Standards Committee

Meeting Agenda

TITLE	Champion
<p>1st time to Committee. Twenty (20) proposed drawings and revisions to WVDOH Standard details Book – Volume 2. The sheets are listed below. A summary of each sheets revisions are included in the meeting packet; and proposed sheets have revised areas highlighted yellow.</p> <ul style="list-style-type: none"> a) <i>TE1-3A Roadside Sign Supports Steel Beam Type</i> b) <i>TE1-3B Roadside Sign Supports Steel Beam Type</i> c) <i>TE1-3C Roadside Sign Supports Steel Beam Type</i> d) <i>TE2-1A Bridge or Retaining Wall Sign Mounting, Type K 1 & 2 Supports</i> e) <i>TE2-1B Bridge or Retaining Wall Sign Mounting, Type K 1 & 2 Supports</i> f) <i>TE2-2 Bridge or Retaining Wall Sign Mounting, Type L Pipe Post Mount</i> g) <i>TE2-3 Barrier Wall Sign Support Bracket Type D</i> h) <i>TE3-1 Overhead Sign Support – Steel Two Tube Span (TTS)</i> i) <i>TE3-2 Overhead Sign Support – Steel One Tube Span (OTS)</i> j) <i>TE4-3A Overhead Sign Support – Steel Double Arm Cantilever</i> k) <i>TE4-3B Overhead Sign Support – Butterfly Cantilever</i> l) <i>TE4-4A Overhead Sign Support – Single Arm Cantilever (Heavy)</i> m) <i>TE4-4B Overhead Sign Support – Sing

STANDARD SHEET TE1-3A

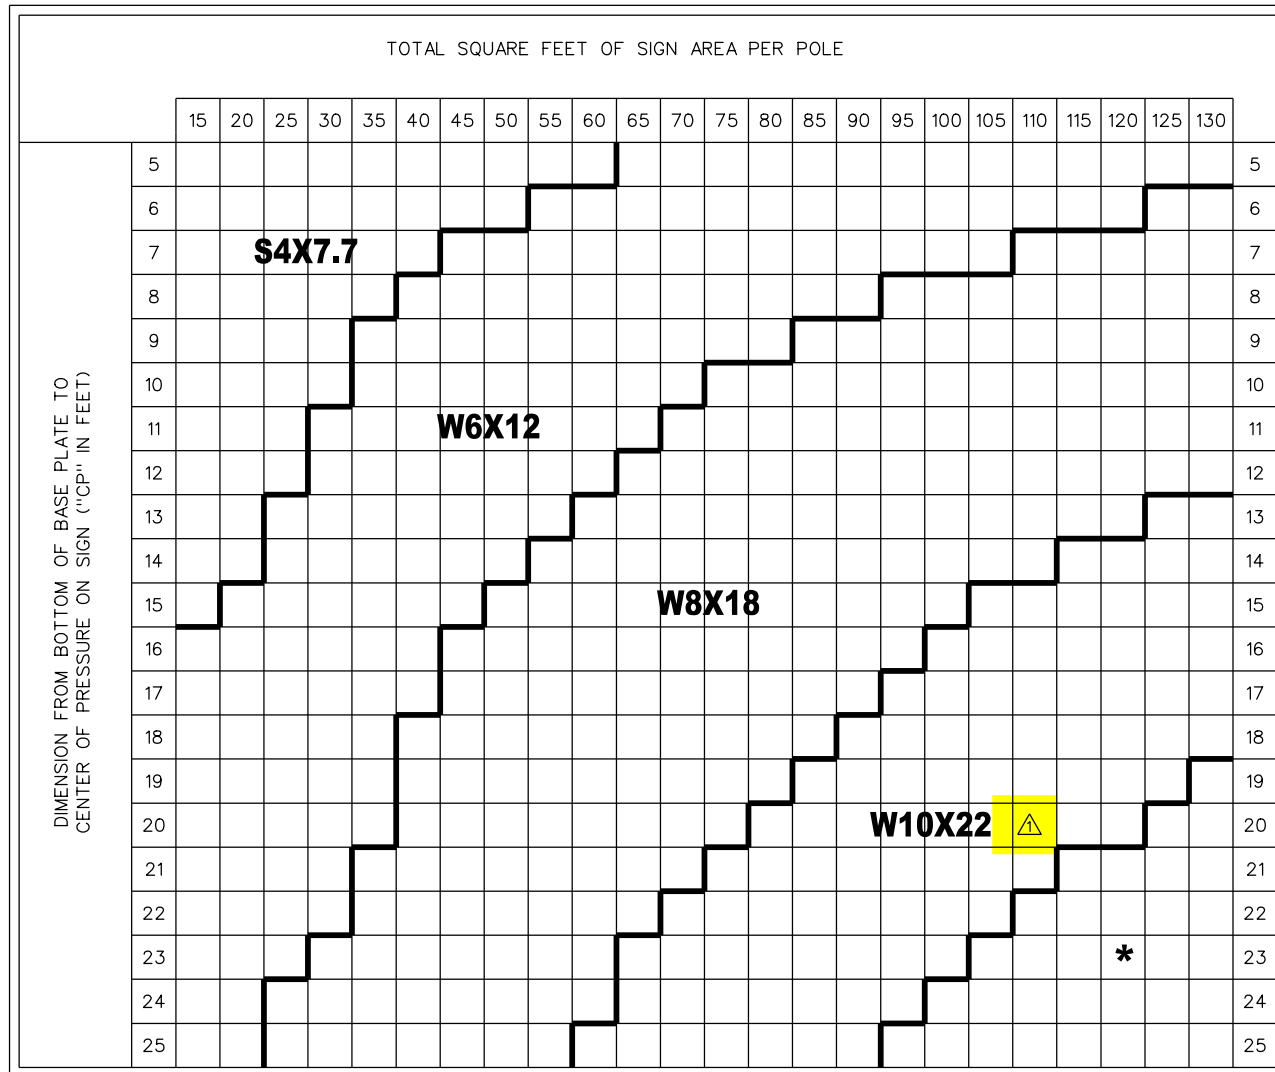
REVISED T3 & D3 FOR S4 & W6 SUPPORTS

STANDARD SHEET TE2-1A

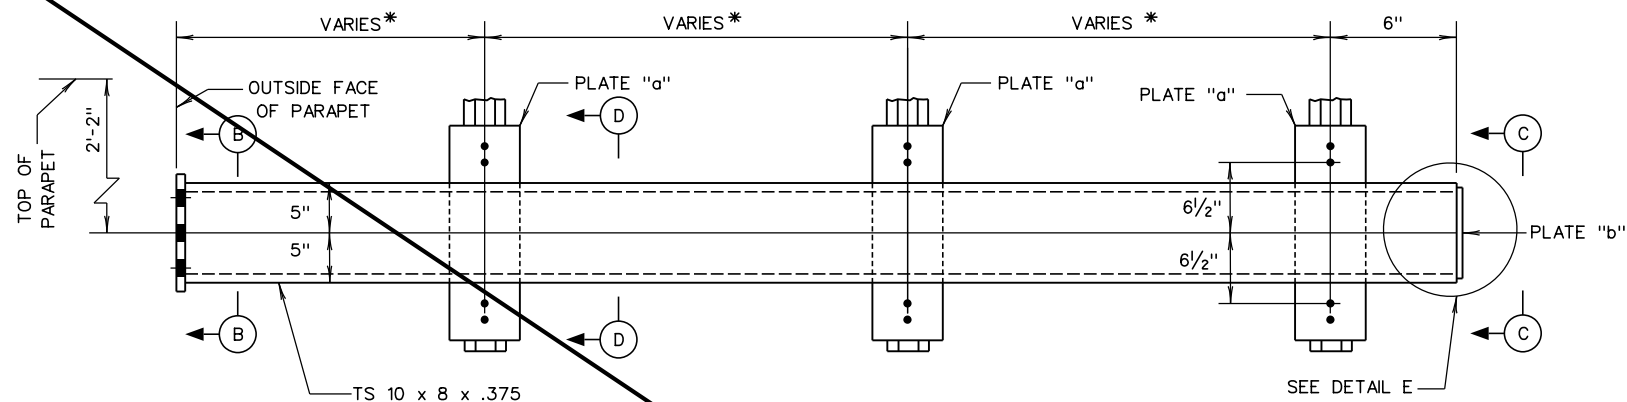
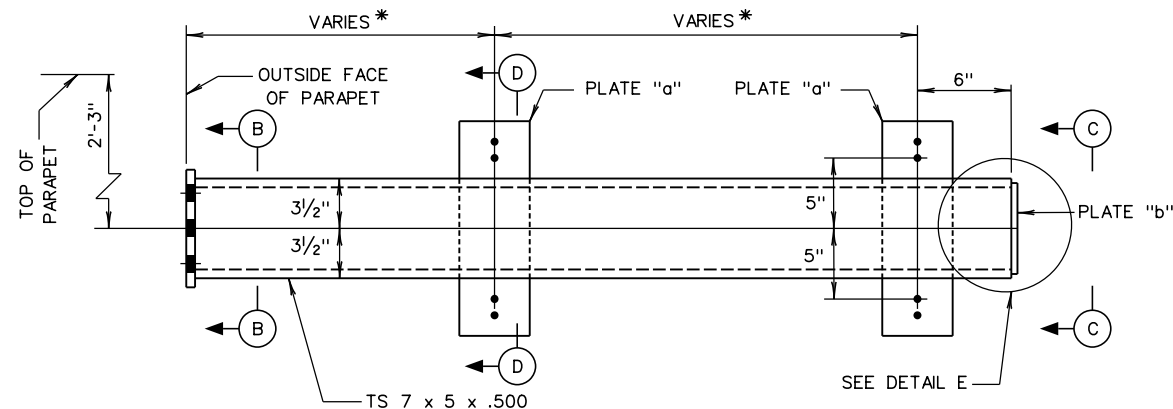
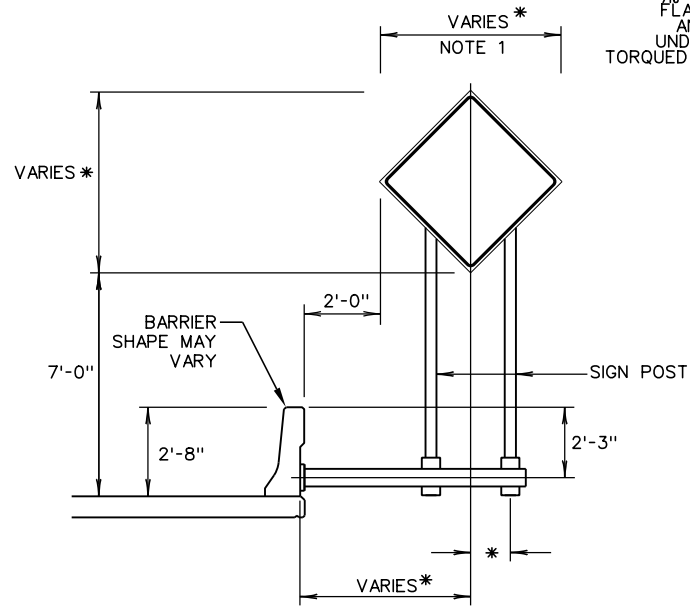
△ REVISED NOTE 2 TO REMOVE REFERENCE TO 3-POST SUPPORT AND LIMIT SIGN WIDTH TO 6'.
REVISED NOTE 3 TO CLARIFY LOADS.
REVISED BASE PLATE DIMENSIONS TO INCREASE BOLT QUANTITY TO 8.

**BRIDGE OR
RETAINING WALL
SIGN MOUNTING
TYPE L
PIPE POST MOUNT
STANDARD SHEET TE2-2**

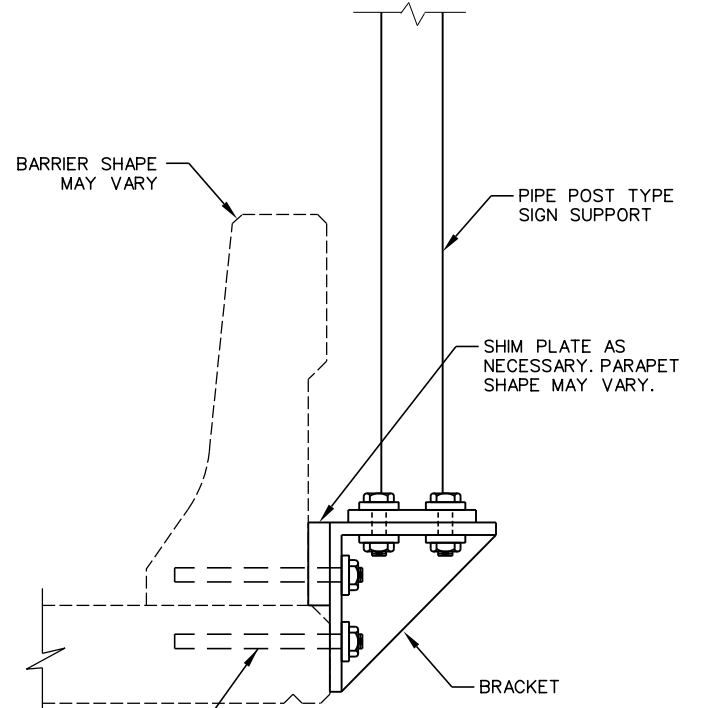
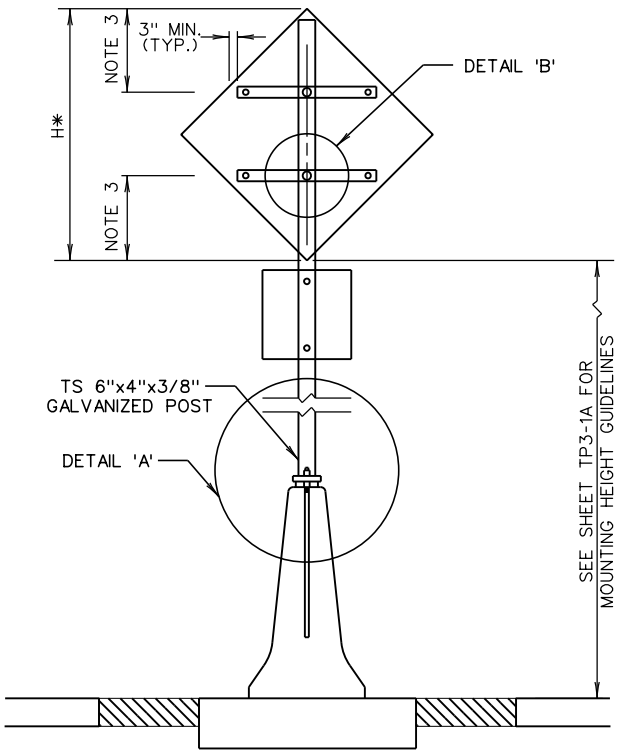
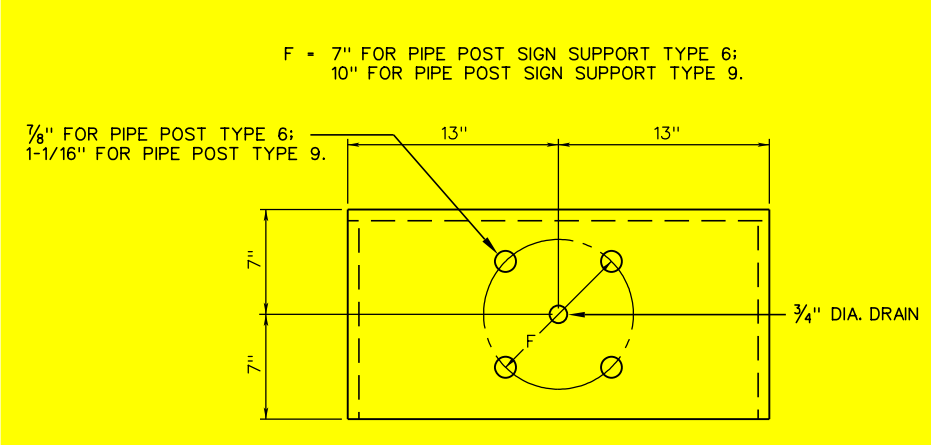
ADDED NOTE 4. REMOVED REFERENCE TO TYPES 7 & 8. INCREASED WIDTH OF BRACKET AND INCREASED NO. OF ANCHORS TO 8.

STANDARD SHEET TE3-2

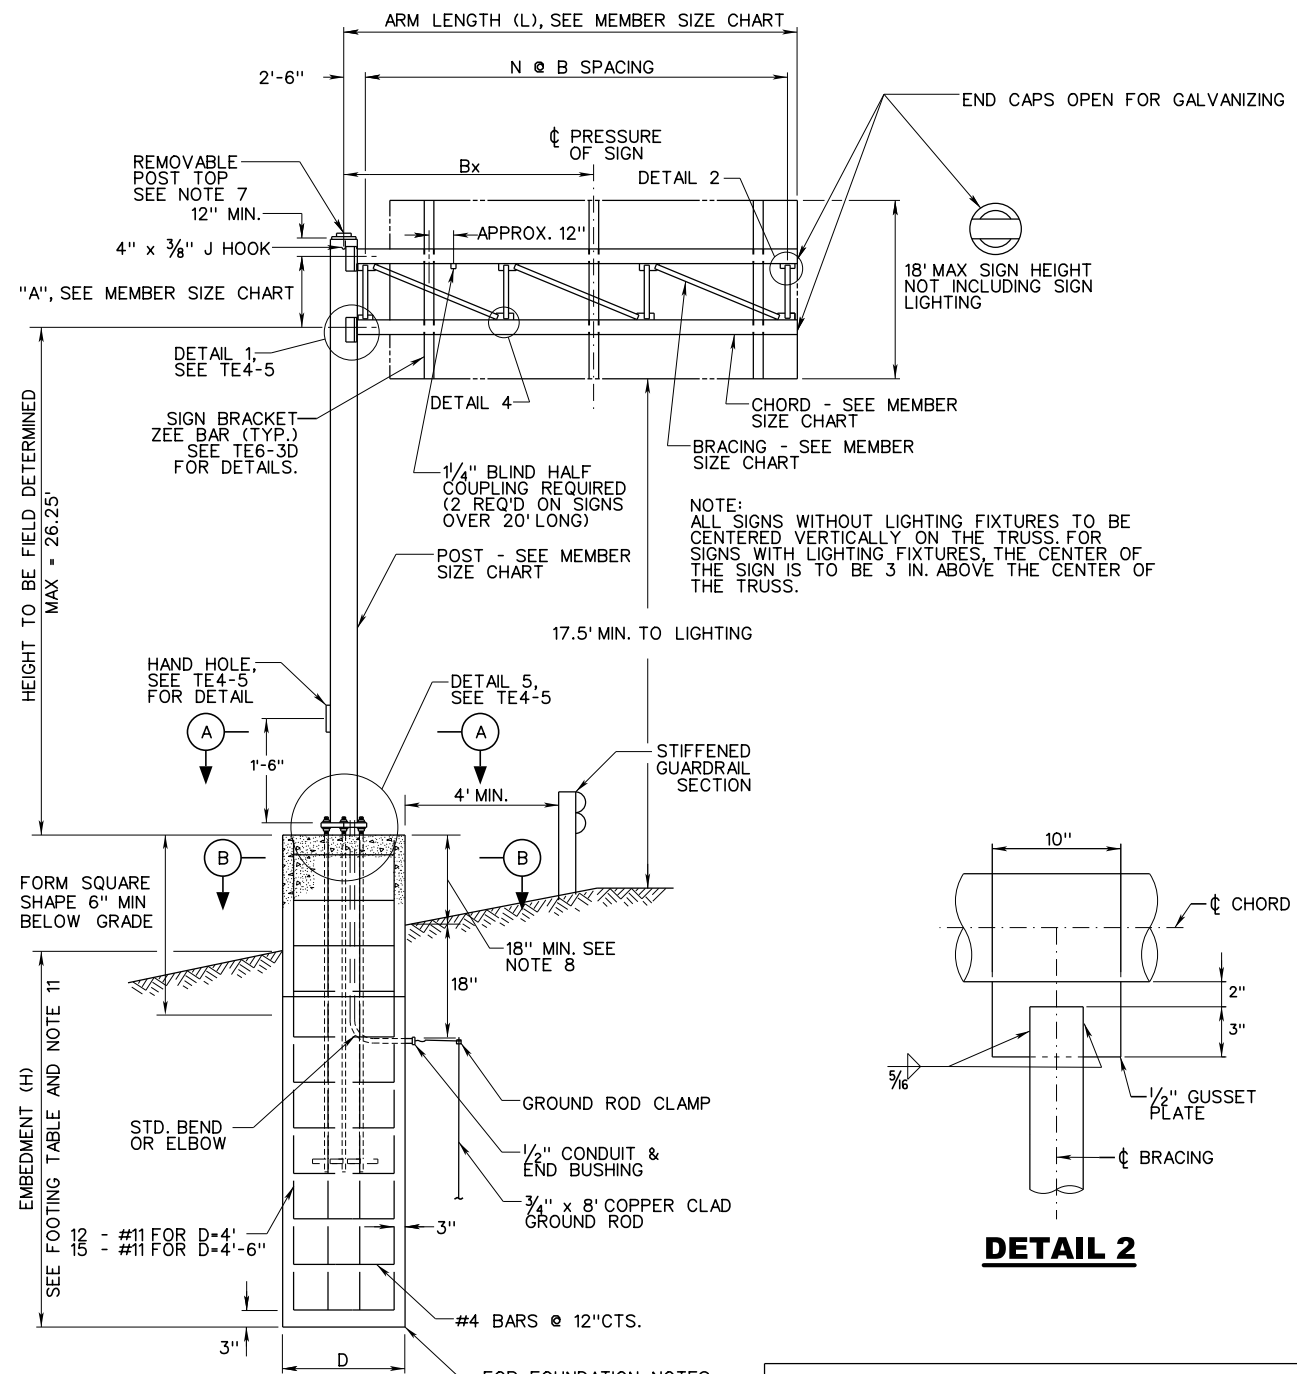
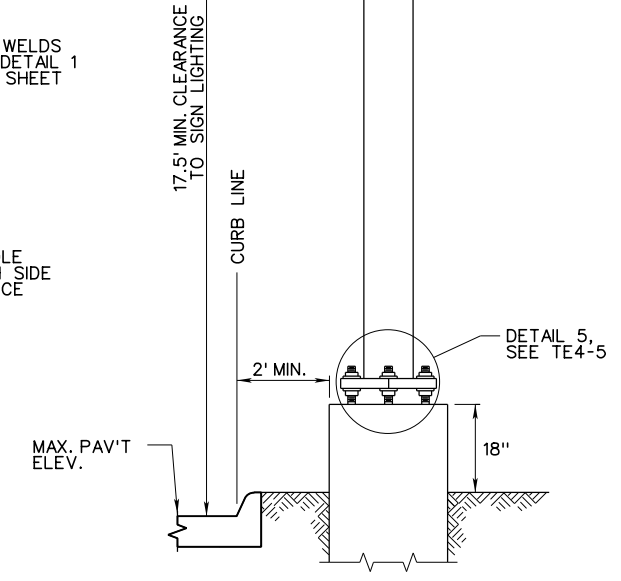
▲ ADDED CAMBER INFORMATION
▲ REVISED TABLE, REVISED BRACKET SIZE

STANDARD SHEET TE4-3A

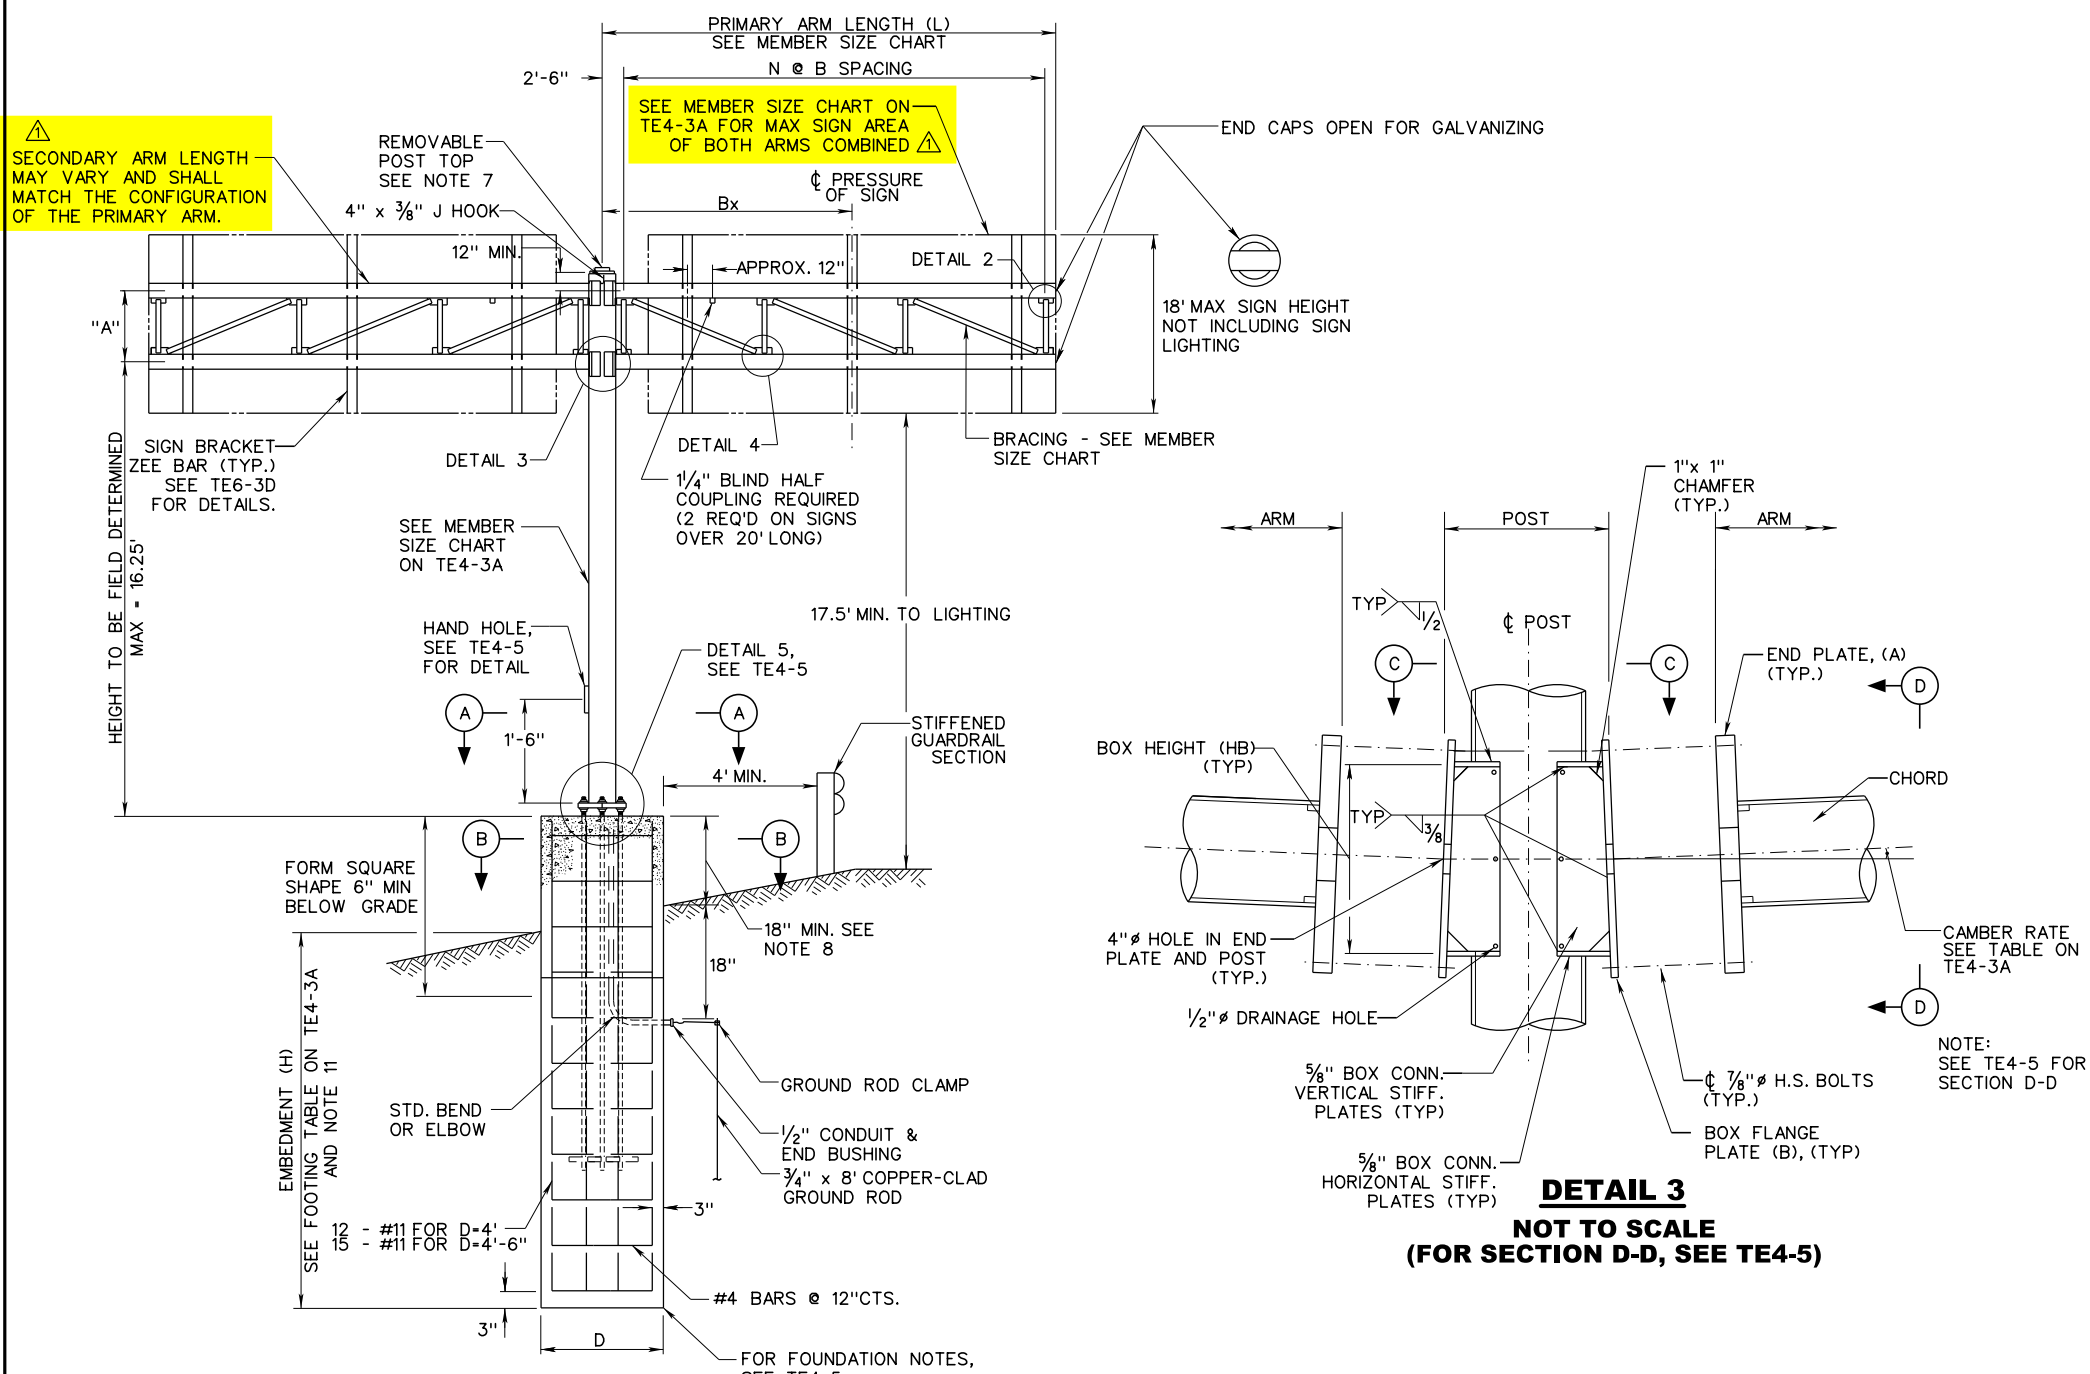
REVISED MEMBER SIZE CHART, FOOTING TABLE, AND BOX CONNECTION TABLE

OVERHEAD SIGN SUPPORT-STEEL
SINGLE ARM CANTILEVER (HEAVY)
STANDARD SHEET TE4-4A

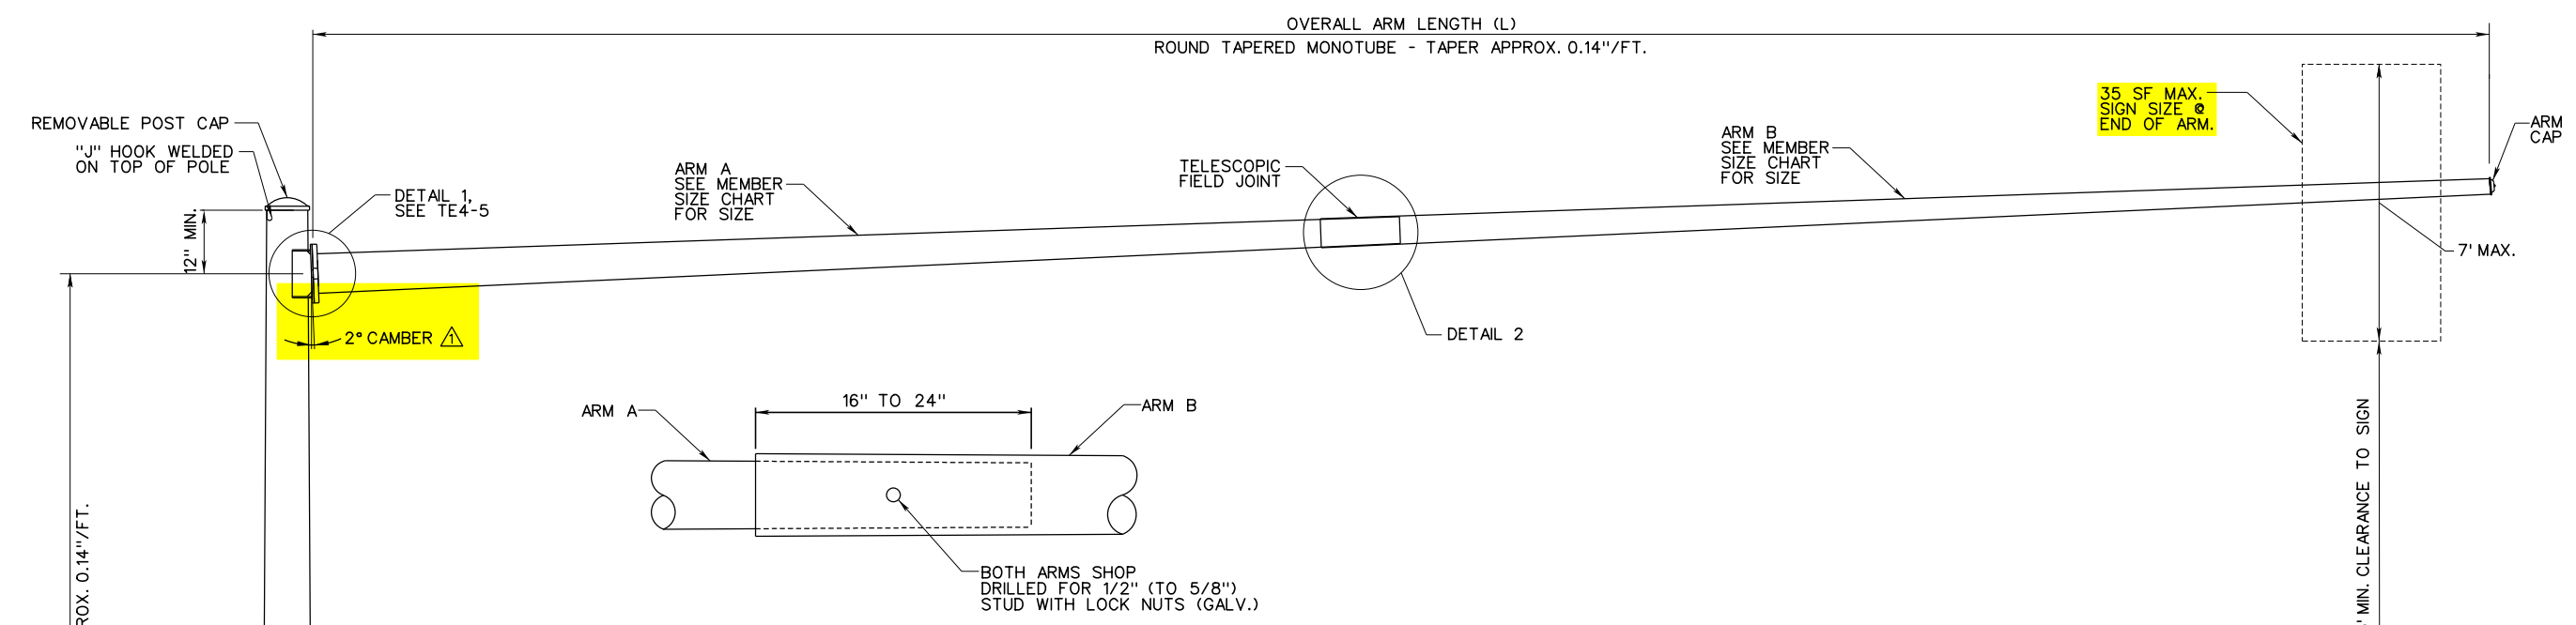
REVISED FOUNDATION DIAMETER AND EMBEDMENT DEPTH FOR 45' & 55' ARM LENGTHS. ADDED SOIL PARAMETER NOTE AND 2:1 MAX. ALLOWABLE SLOPE TO ELEVATIONS. REVISED BOX CONNECTION TABLE TO ADD W DIMENSION. REVISED POST AND ARM SIZES FOR 45' & 55' ARM LENGTHS AND AFFECTED BASE PLATE DIMENSIONS. MOVED FOOTING DIMENSION INFORMATION TO THE CHART. ADDED BASE PLATE HOLE SIZE INFORMATION. ADDED CAMBER DETAIL AND CHART.
